SUBJECT: Transmittal of Responses to AP1000 DSER Open Items

This letter transmits the Westinghouse responses to Open Items in the AP1000 Design Safety Evaluation Report (DSER). A list of the DSER Open Item responses transmitted with this letter is Attachment 1. The proprietary responses are transmitted as Attachment 2. The non-proprietary responses are provided as Attachment 3 to this letter.

Draft Safety Evaluation Report Open Item Response

Figure 440.796f-1. Typical AP600 ADS4 piping layout. View 1.

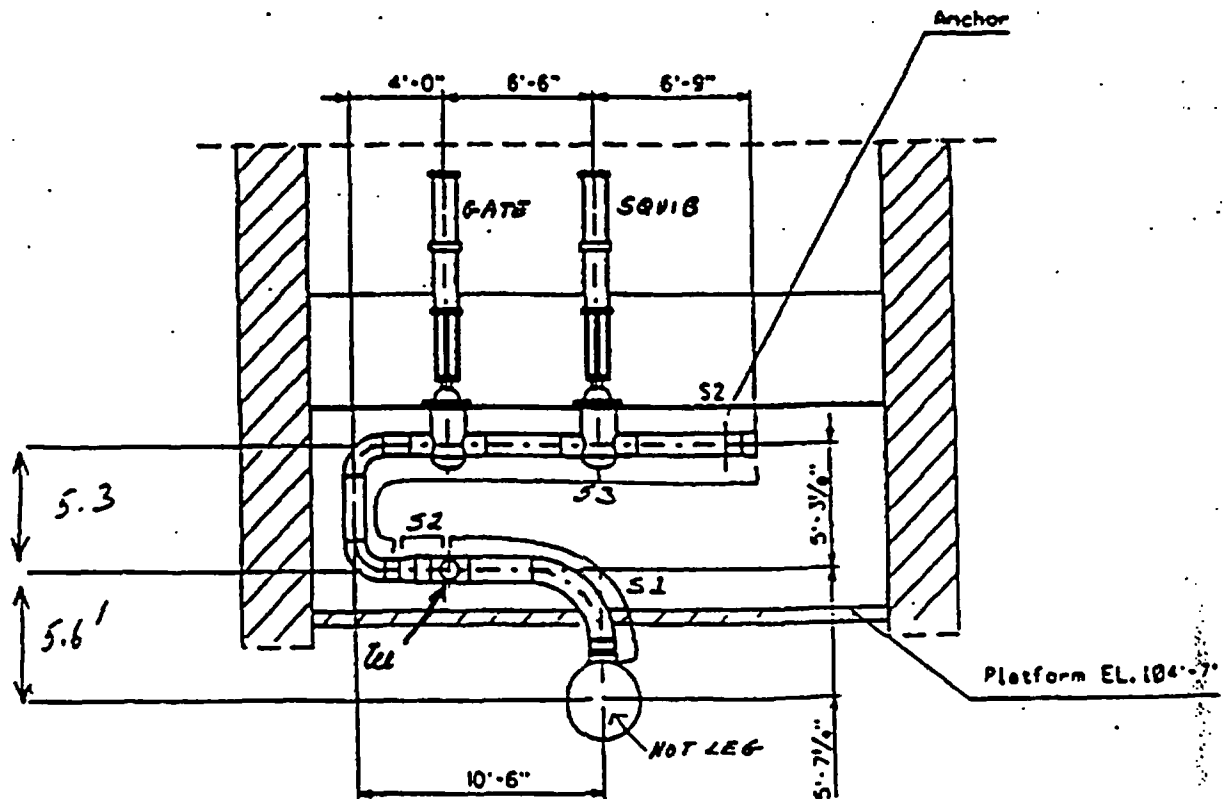
The over prediction by NOTRUMP of ADS4 vapor flow near the end of the transient is not considered to be a significant problem because of the bounding nature of the ADS4 piping which was modelled. As shown in Figure 440.796f-1, the number of elbows and lengths of piping in actual designs will be substantially less than what was assumed in the NOTRUMP calculation. In addition, pressure losses due to acceleration were maximized by assuming homogeneous fluid conditions.

Figure 440.796f-6. Static pressure in ADS4 piping for hot leg pressure = 50 psia, quality = 20%.

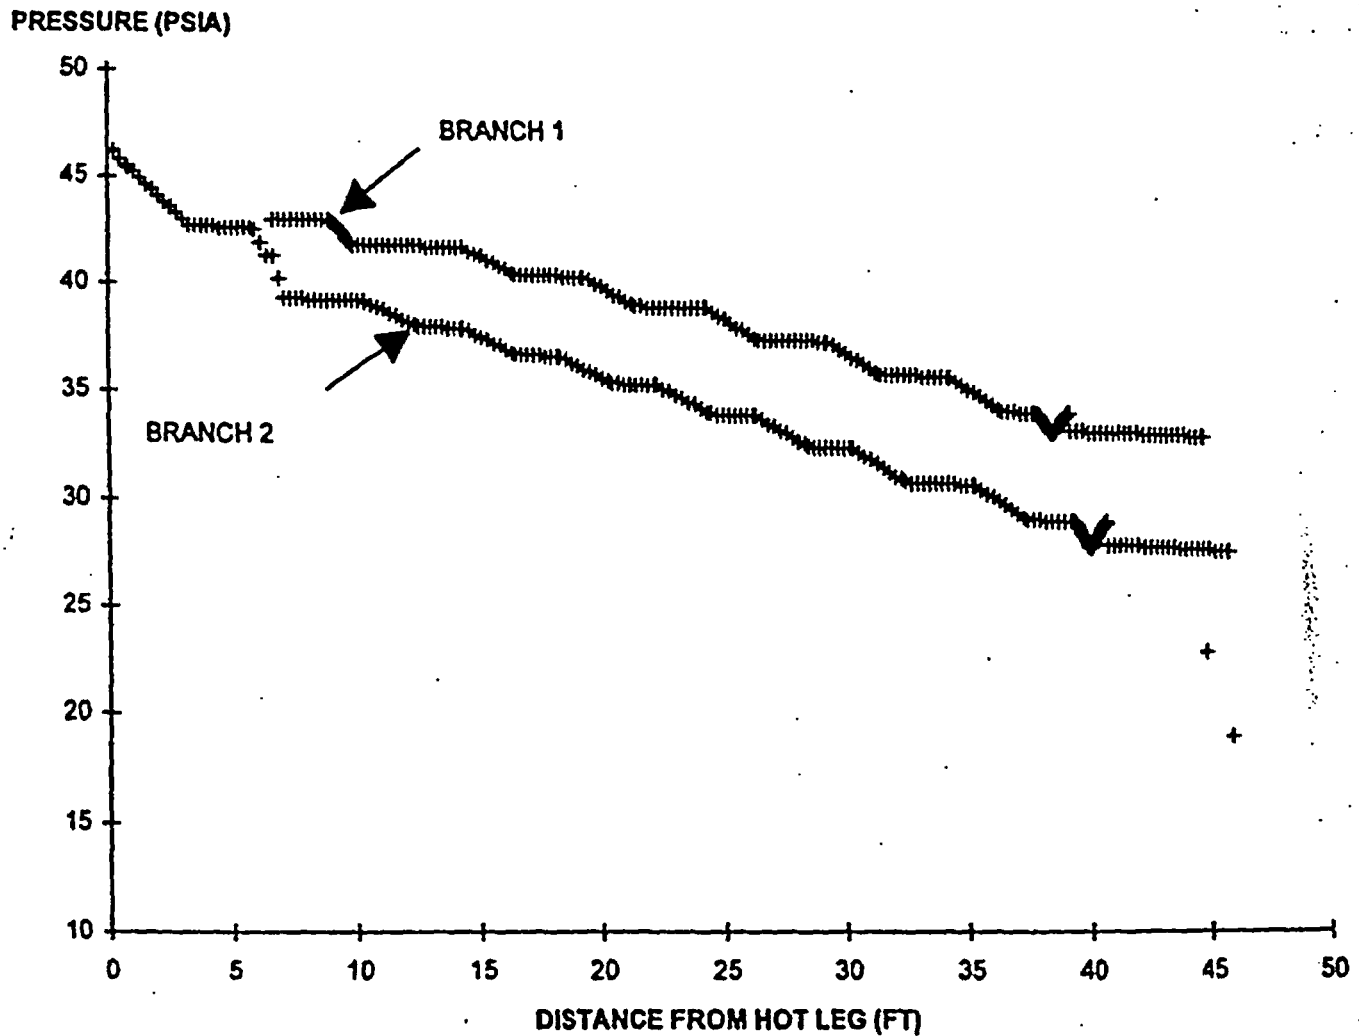
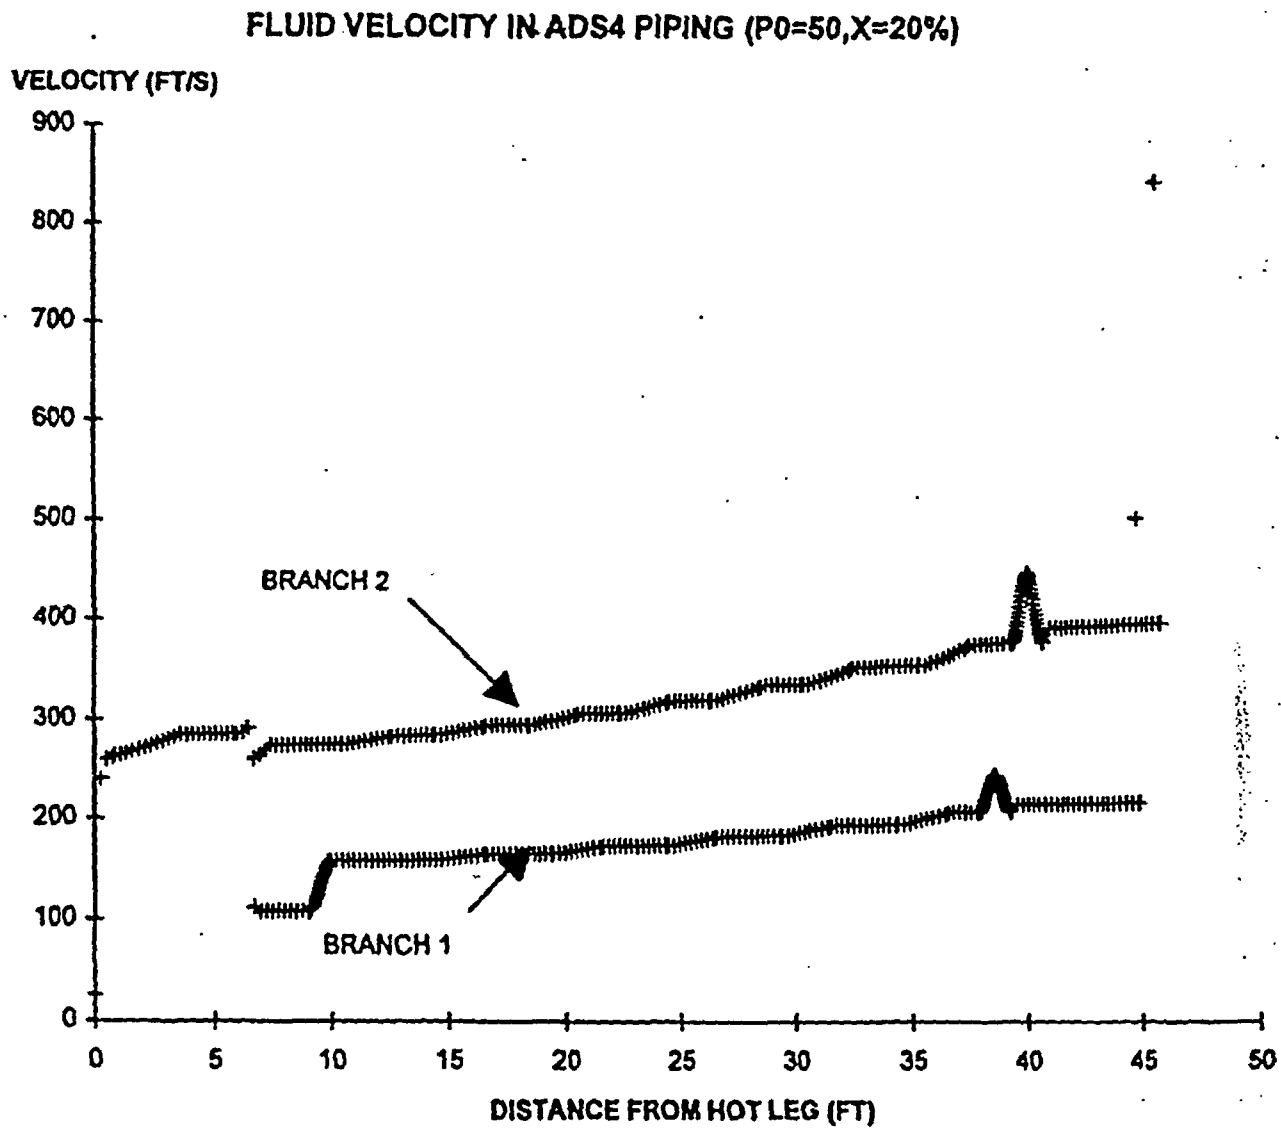
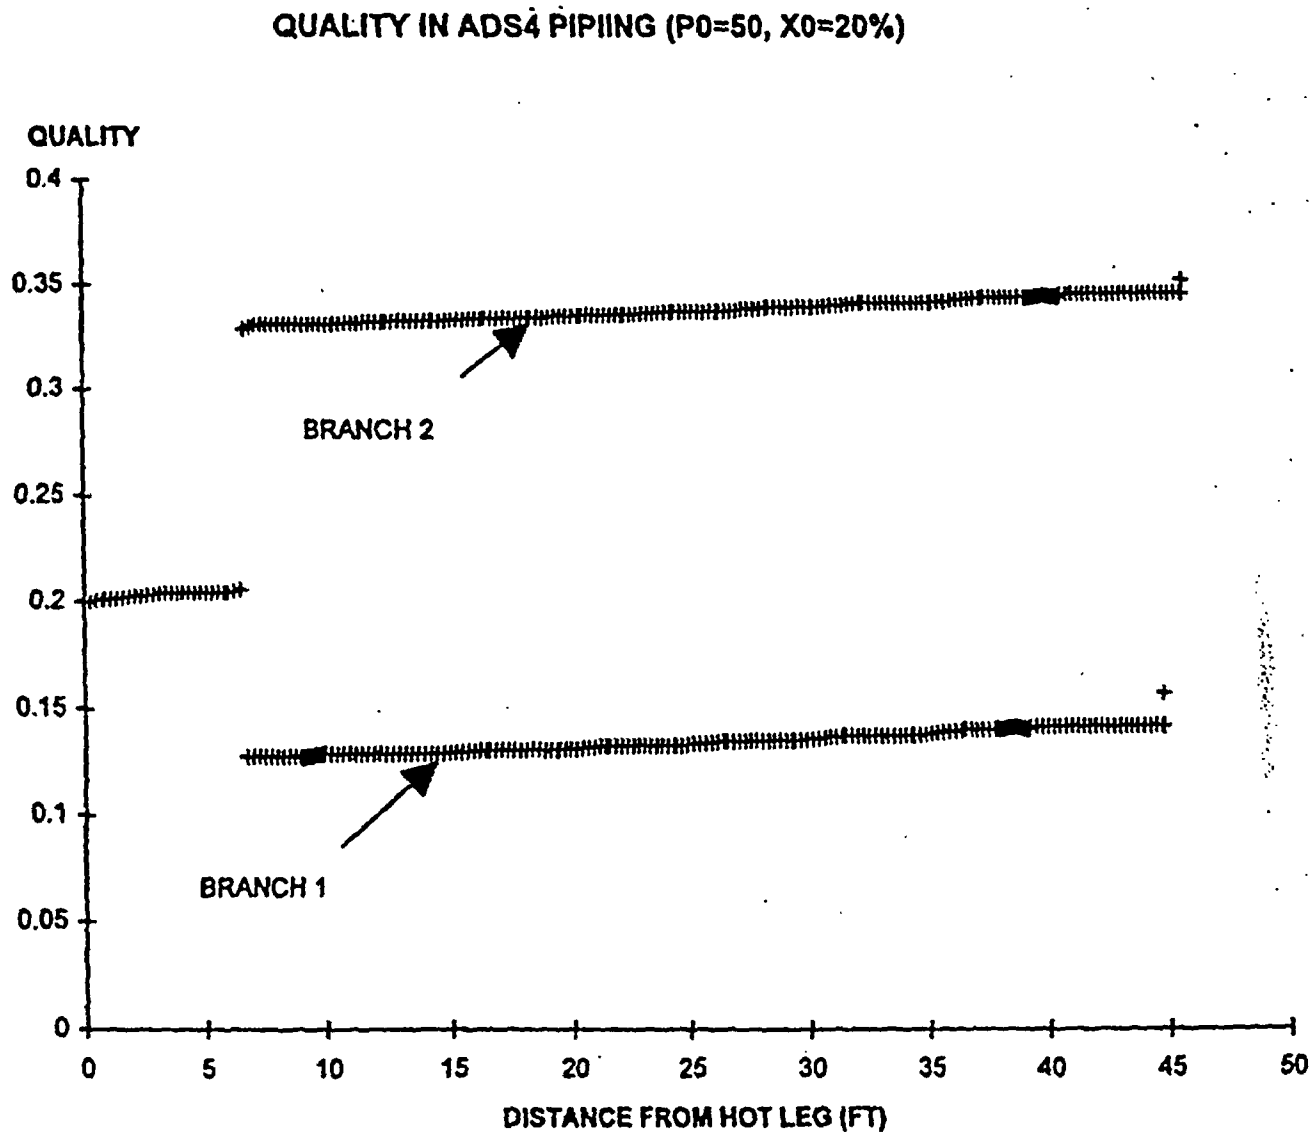
Figures 440.796f-6 to 8 show conditions when the flow quality is 20%. In this case, phase separation occurs at the tee, with a higher quality mixture flowing into branch 2 (Figure 440.796f-8). Calculations assuming no separation occurs show that this phenomenon has a negligible effect on the amount of vapor which can be vented.

Figure 440.796F-9. Vapor flow vs hot leg pressure and quality predicted by pipe model.

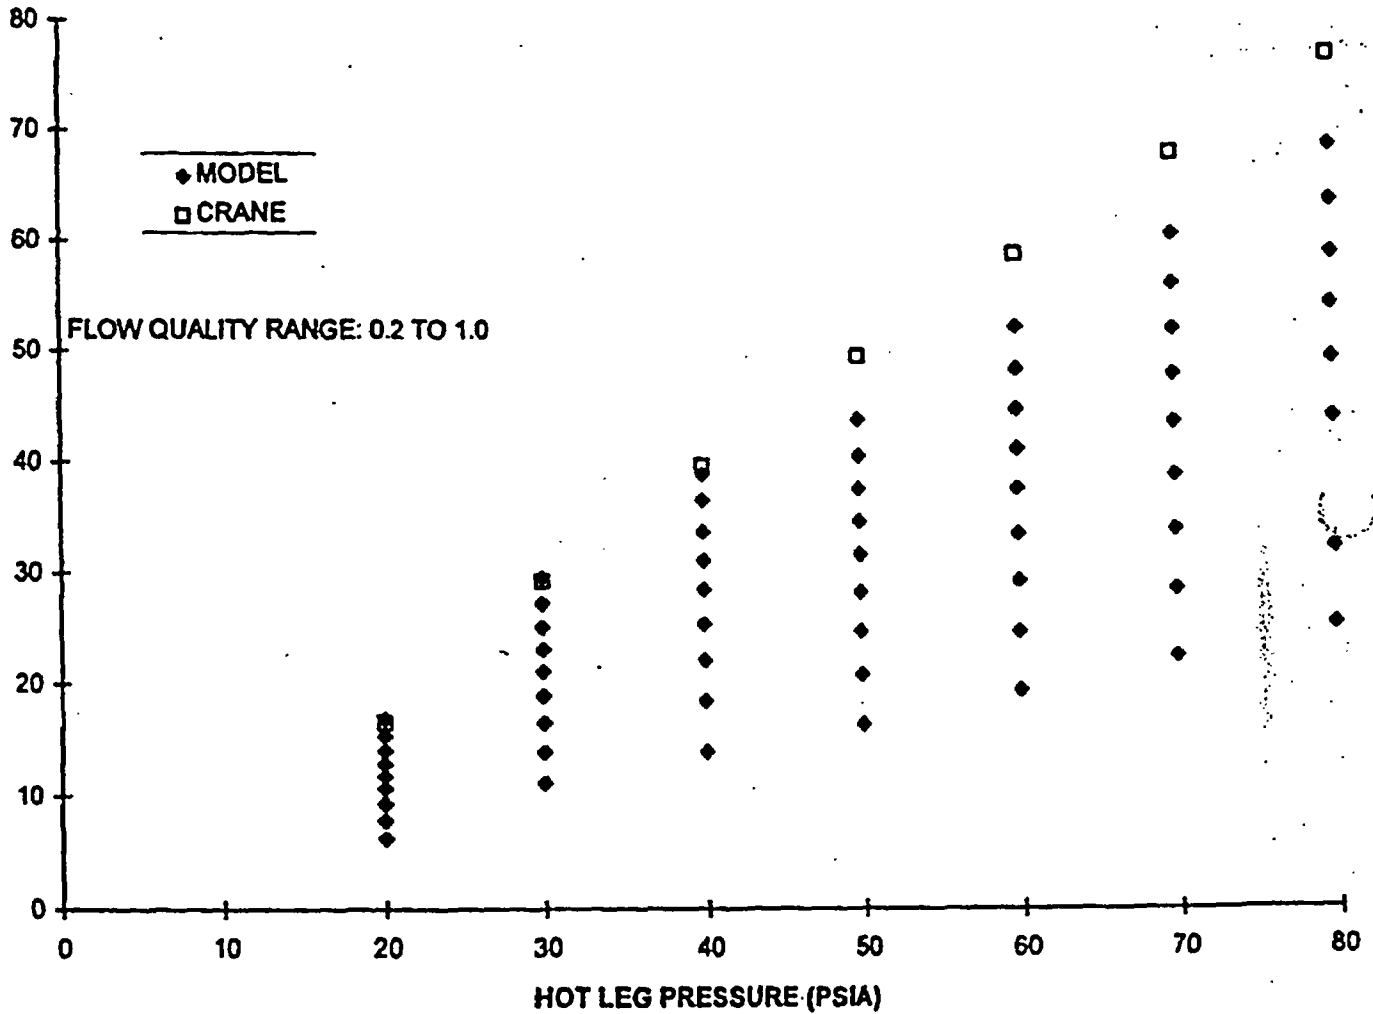
Vapor flow versus hot leg pressure for a range of flow qualities predicted by the model are shown in Figure 440.796f-9. The 100 percent quality data show good agreement with points estimated from a handbook, shown in Figure 1.7-9 of Reference 1. At approximately 40 psia, critical flow is calculated to occur at the squib valve, and the model and handbook data begin to diverge.

Figure 440.796f-10. Comparison of NOTRUMP and pipe model vapor flows

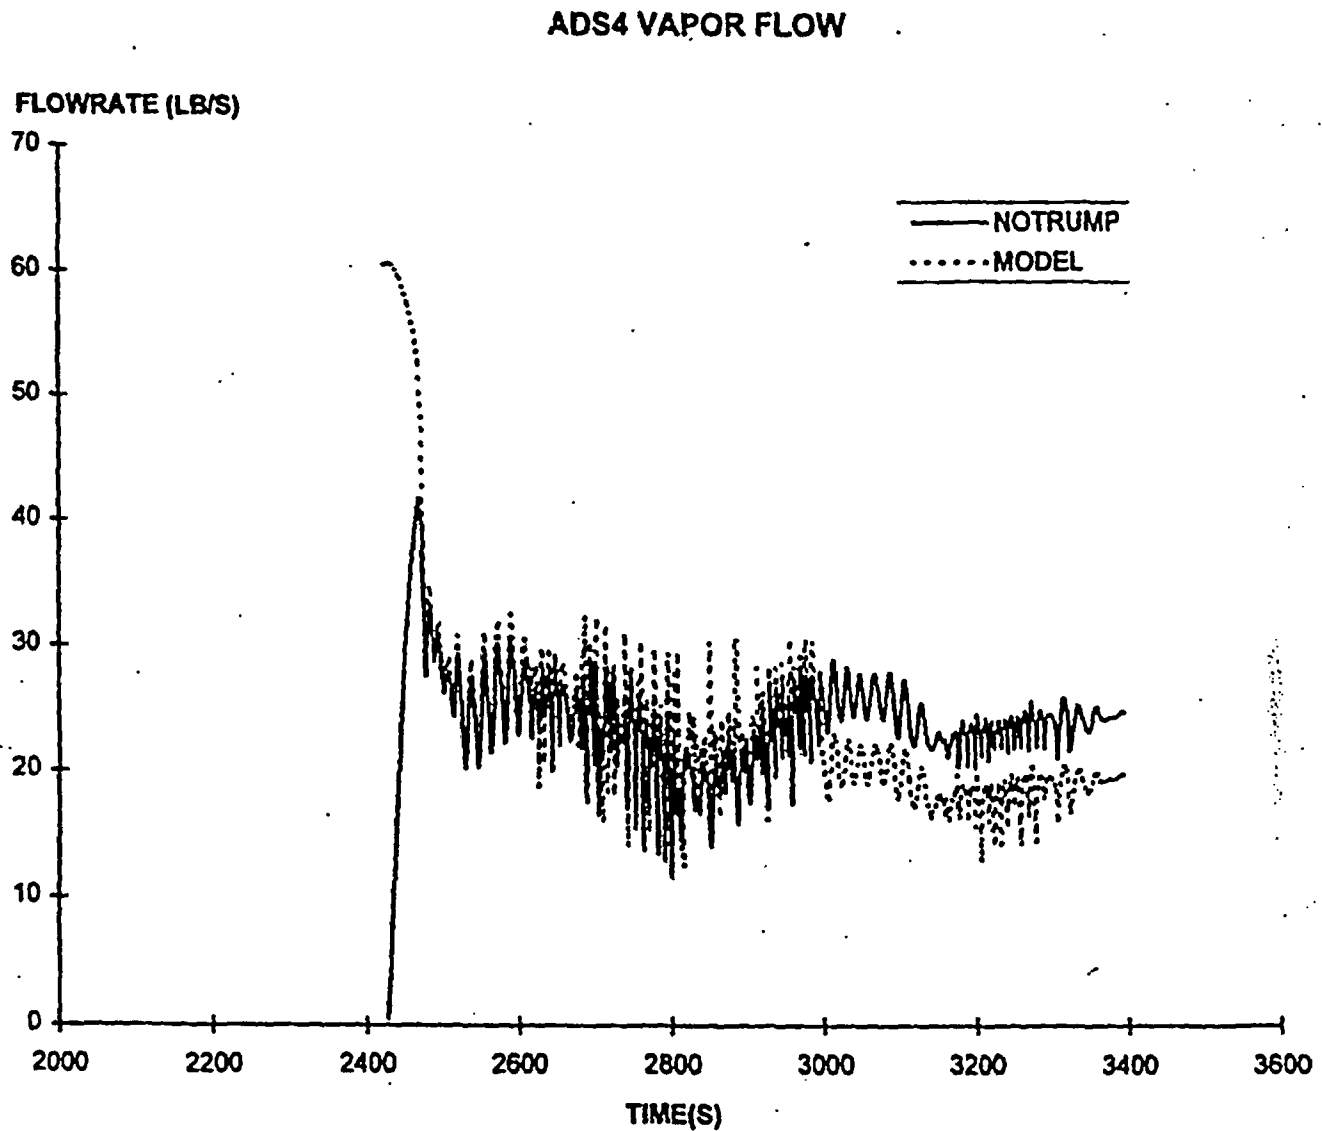
The model calculated data were used to generate a response surface which were then used to calculate ADS4 vapor flow, given hot leg pressure and quality from NOTRUMP. This comparison is shown in Figure 440.796f-10 for the time period between ADS4 opening and IRWST injection. These figures show good agreement between NOTRUMP and the detailed model, as long as critical flow conditions exist prior to 3000 seconds. The good agreement during choked flow indicates that the flow resistance upstream of the squib valve has a minor impact on the flow, even with the relatively high fluid velocities noted. When the flow becomes sub-critical, NOTRUMP predicts a higher vapor flow of about 20 percent (corresponding roughly to a 35 percent lower flow resistance). Overall, the total vapor vented is underpredicted by NOTRUMP soon after opening, then is overpredicted, as seen in Figure 440.796f-11. However, the NOTRUMP total vapor released is only about 5 percent higher at the time the IRWST comes on. Comparison of NOTRUMP and model details indicates that the difference during sub-critical flow can be attributed to:

Figure 15.6.5.4C-2: Core Average Collapsed Level

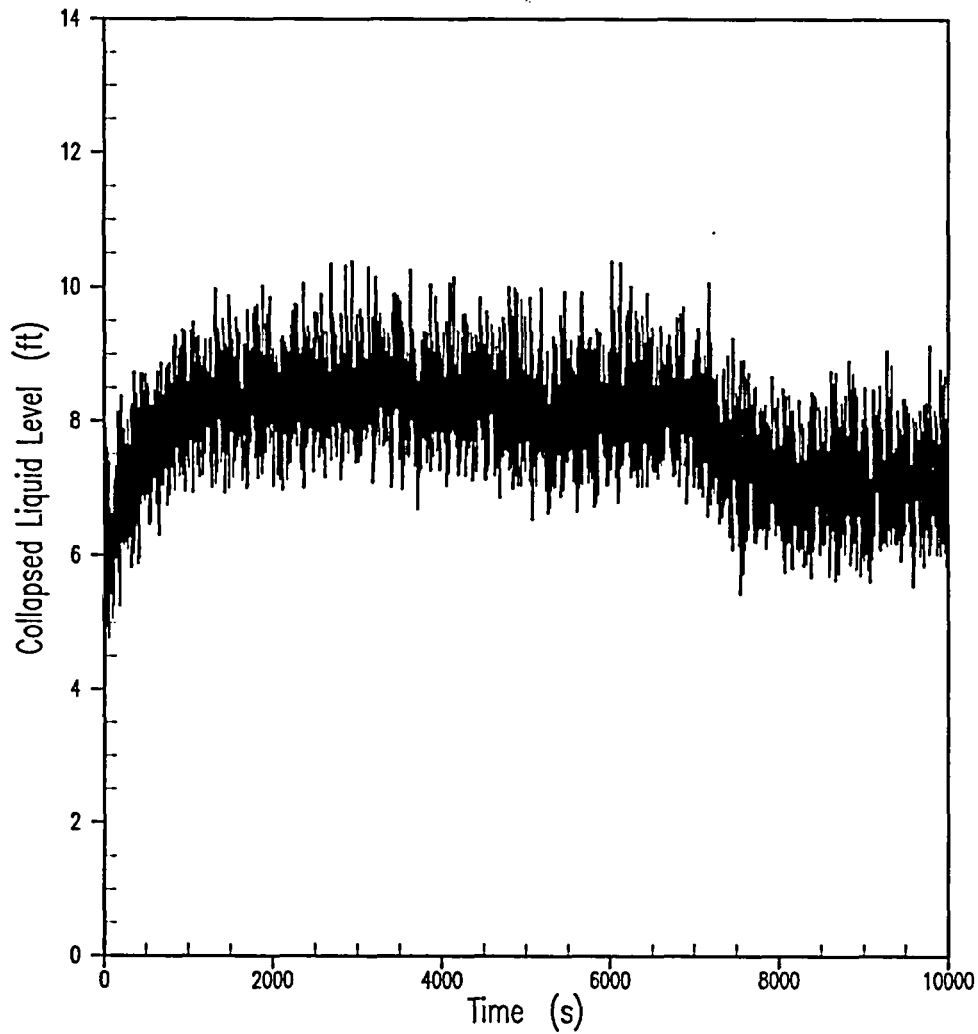
Boiling in the core produces steam and a two-phase mixture, which flows into the upper plenum. The core is 14 feet high, and the core average collapsed liquid level (Figure 15.6.5.4C-2) is shown from the start of long-term cooling. The boiling process causes a variable rate of steam production and resulting pressure changes, which in turn causes oscillations in the liquid flow rate at the bottom of the core and also

Figure 15.6.5.4C-11: Upper Plenum Pressure

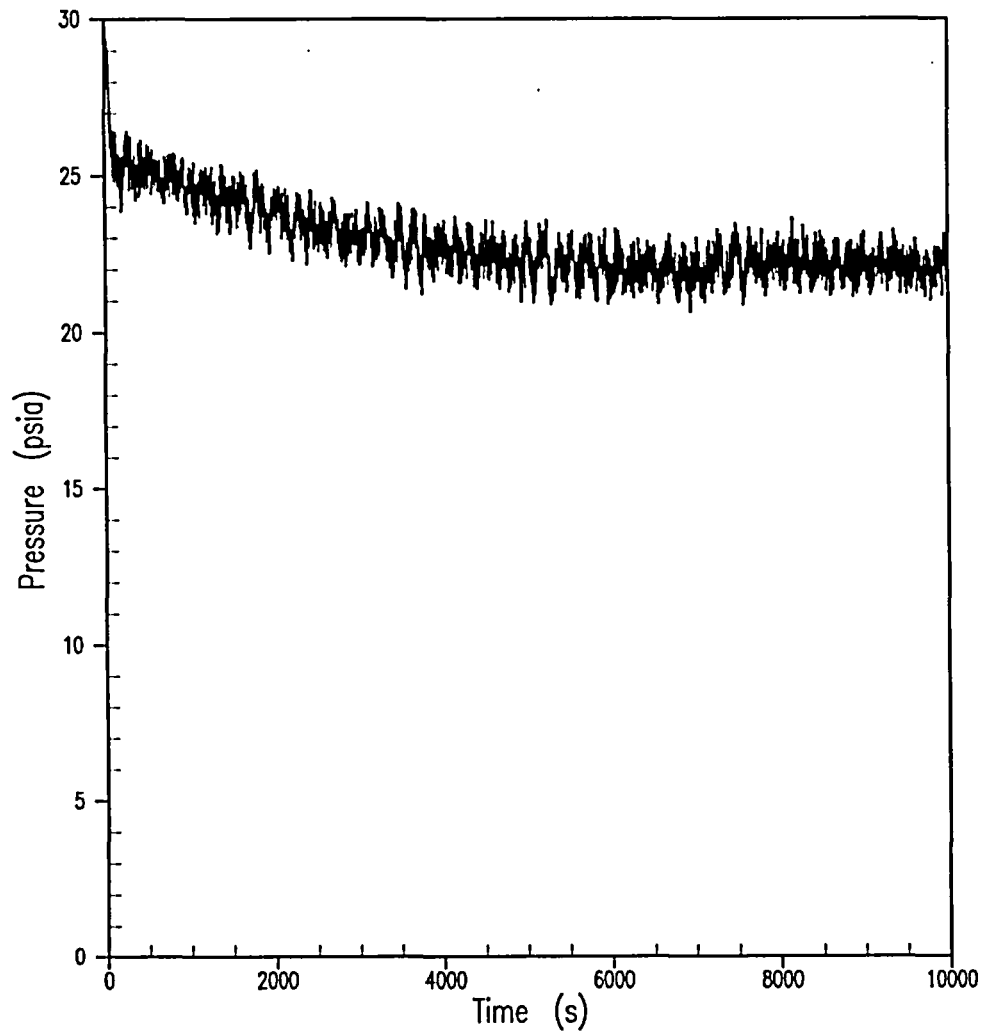
The pressure in the upper plenum is shown in Figure 15.6.5.4C-11. The upper plenum pressure fluctuation that occurs is due to the ADS Stage 4 water discharge. The PCT of the hot rod follows saturation temperature (Figure 15.6.5.4C-12), which demonstrates that no uncover and no cladding temperature excursion occurs. A small pressure drop is calculated across the reactor vessel, and injection rates through the DVI lines into the vessel are presented in Figures 15.6.5.4C-13 and -14. Figure 15.6.5.4C-14 shows the flow is outward through the broken DVI line at the start of the long-term cooling period, and it increases to a maximum average value of about 52 lbm/s after the compartment water level has increased above the nozzle elevation to permit liquid injection into the reactor vessel. In contrast, the intact DVI line flow falls from 170 lbm/s with a full IRWST to about 65 lbm/s flow from the containment at the end of the calculation. The recirculation core liquid throughput is more than adequate to preclude any boron buildup on the fuel.
